Glyn Rhonwy Pumped Storage Development Consent Order

Deadline 2 – Applicants response to Relevant Representations

PINS Reference	EN010072	
Document Nos.	SPH_GREX_RRD2_01	
Authors	SPH/AECOM/GVA/BS	
Revision	Date	Description
1	April 2016	Issued

Figure 1. Typical magnetic fields from overhead lines

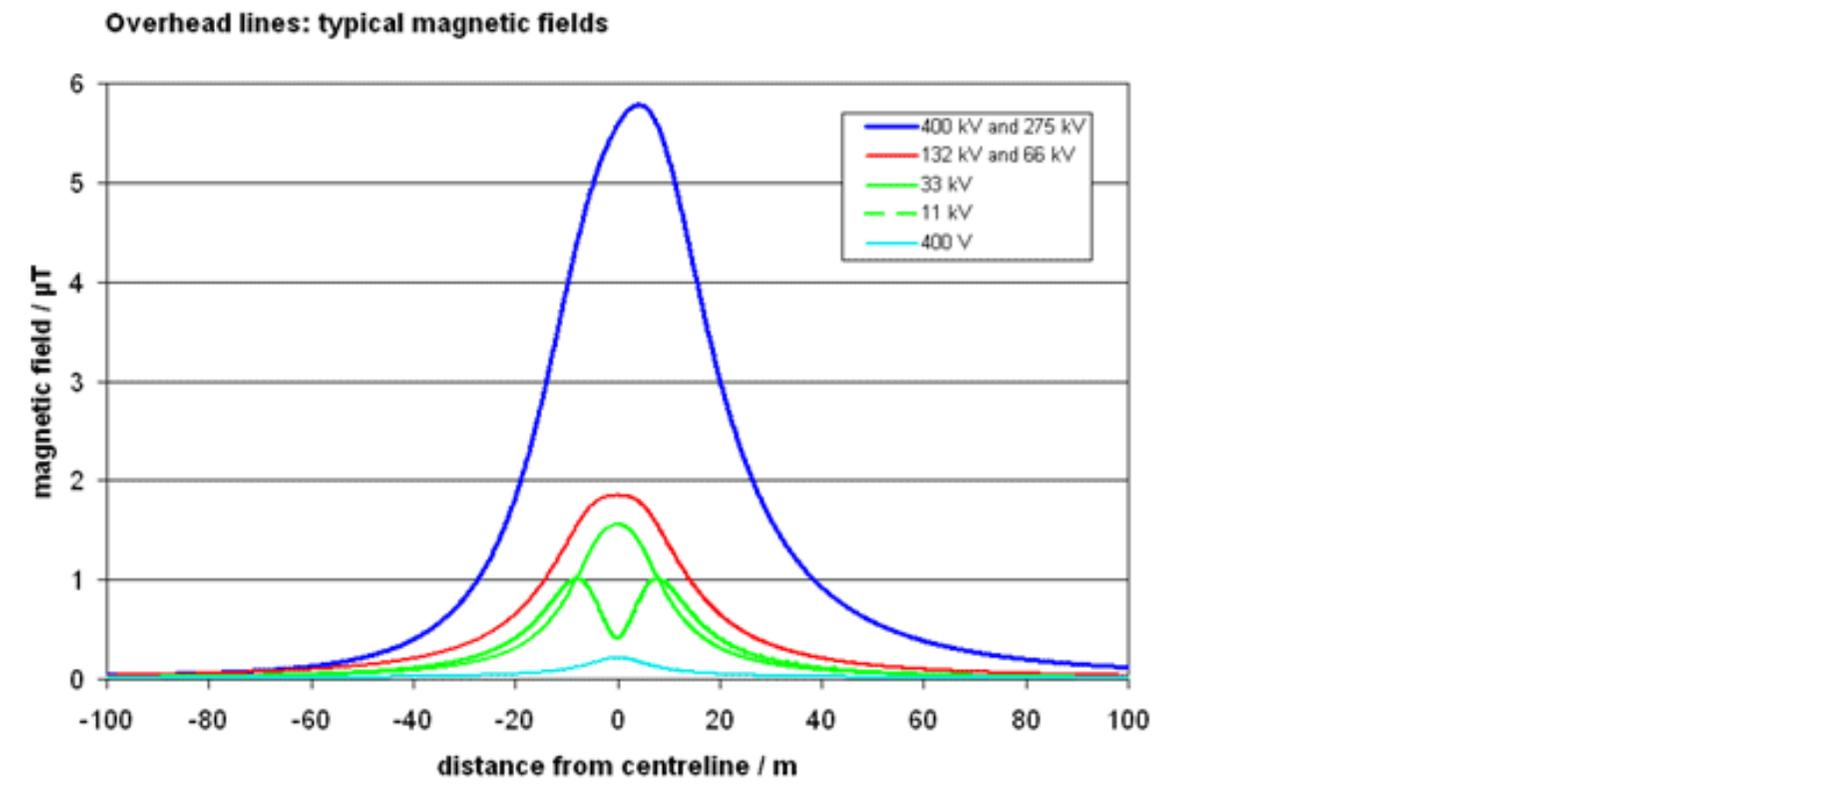
PHE, including PHE's Centre for Radiation, Chemical and Environmental Hazards (Wales), has considered the submitted documentation. Whilst we are broadly satisfied with the conclusions drawn within the ES, we note however, that our previous request (dated 5th March 2015) in considering the potential health impact associated with electric and magnetic fields (EMF) has not been specifically addressed. It is important that all aspects of the development are considered at this stage and would request this aspect be undertaken for PHE to consider.

Due to the size of the equipment and location within an enclosed building, it is unlikely that the scale and nature of the electrical equipment within the power house will cause any significant effects to local residents.

In 1998, the International Commission on Non-Ionizing Radiation Protection (ICNIRP) issued revised guidelines reference level

of 100 μT for public exposure to magnetic fields at power frequencies . In 2010, the ICNIRP increased this reference level to a less stringent 200 μT , although the previous remains the basis of UK guidance

Underneath power lines, magnetic fields can be around 20 μT , which is considerably lower than the ICNIRP guidelines. The magnetic field also reduces with distance as demonstrated in an example on overhead lines in Figure 1.

It is anticipated that the above ground structures containing electrical equipment will be installed at least 400m from any residential area, therefore it is expected that the magnetic field level will be significantly less than 20 μ T. Accordingly, the authorised development will operate in compliance with the ICNIRP guidelines.
